95.7 PMD to MDI optical specifications for 100GBASE-SR4

95.8.5 Transmitter vertical eye closure (TxVEC)

Figure 95–3—TxVEC conformance test block diagram

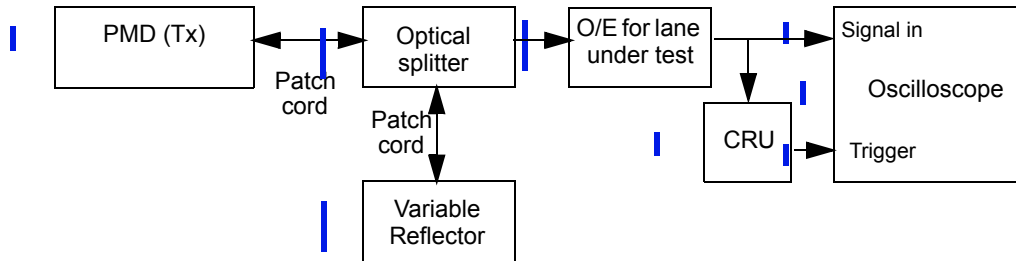
95.8.5.1 TxVEC conformance test set-up

A block diagram for the TxVEC conformance test is shown in Figure 95–3. Other measurement

implementations may be used with suitable calibration.

Each optical lane is tested individually with all other lanes in operation. The optical splitter and variable reflector are adjusted so that each transmitter is tested with an optical return loss of 12 dB.

The combination of the O/E and the oscilloscope used to measure the optical waveform has a fourth-order Bessel-Thomson filter response with a bandwidth of 12.6 GHz. Compensation may be made for any deviation from an ideal fourth-order Bessel-Thomson response.

The clock recovery unit (CRU) has a corner frequency of 10 MHz and a slope of 20 dB/decade.

Figure 95-4—Illustration of the TxVEC measurement

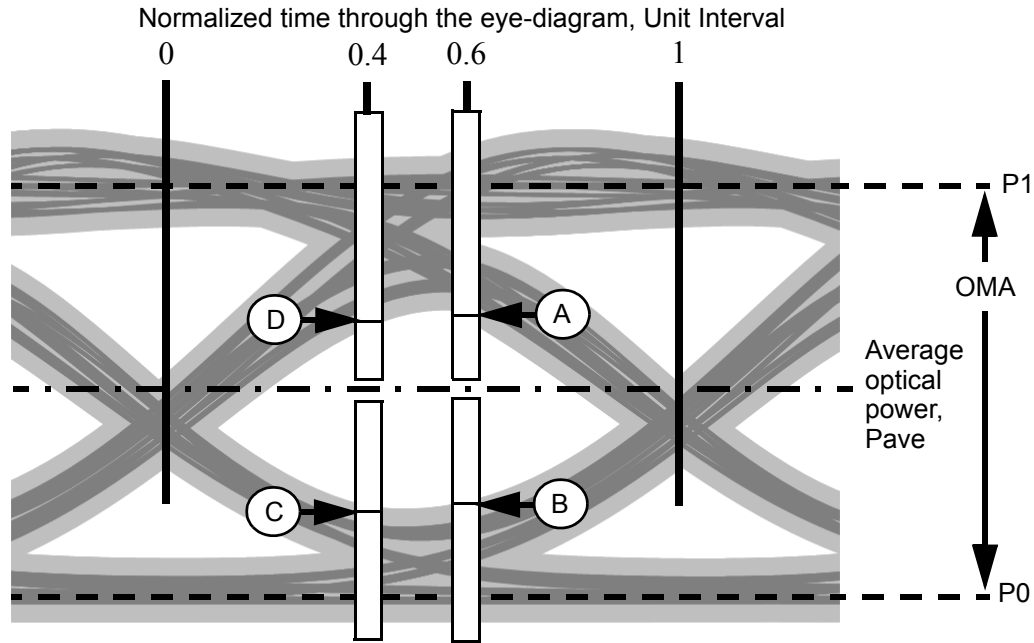
95.8.5.2 TxVEC measurement method

The oscilloscope is set up to accumulate samples for the optical eye-diagram of the transmitter under test, as illustrated in Figure 95–4.

OMA is measured according to 95.8.4. The power of the optical zeros (P0) and the power of the optical ones (P1) are recorded.

The average optical power and the crossing points of the eye-diagram, and the four vertical histograms used to calculate TxVEC, are measured using Pattern 3 or Pattern 5.

The 0 UI and 1 UI crossing points are determined by the time average of the eye crossing points, as measured at the average optical power level, as illustrated in Figure 95–4.

Four vertical histograms are measured through the eye, centered at 0.4 UI and 0.6 UI, and above and below the average optical power of the eye-diagram, as illustrated in Figure 95–4.

Each histogram has a width of 0.04 UI. Each histogram window has one height boundary set close to average power level of the eye-diagram, and the other height boundary is set beyond the outer-most samples of the eye, so that no further eye samples would be captured by increasing the outer boundary of the histogram. Starting from the boundary of the histogram closest to the average optical power level, the optical power at which the cumulative distribution of each histogram equals the 0.005th percentile of the total number of samples for each histogram is recorded (these are the powers A, B, C, and D illustrated in

Figure 95-4).

TxVEC is defined as the largest of the four quantities given by Equation (95-1) to Equation (95-4):

$$TxVEC(A) = 10\log_{10}\left(\frac{P1 - Pave}{A - Pave}\right) \quad (95-1)$$

$$TxVEC(B) = 10\log_{10}\left(\frac{Pave - P0}{Pave - B}\right) \quad (95-2)$$

$$TxVEC(C) = 10\log_{10}\left(\frac{Pave - P0}{Pave - C}\right) \quad (95-3)$$

$$TxVEC(D) = 10\log_{10}\left(\frac{P1 - Pave}{D - Pave}\right) \quad (95-4)$$

P_{ave} is the average optical power of the eye-diagram
P₀, P₁ are the optical one and optical zero levels of the eye-diagram
A, B, C, D are the 0.005th percentile optical power levels of the four vertical histograms described in 95.8.5.2.
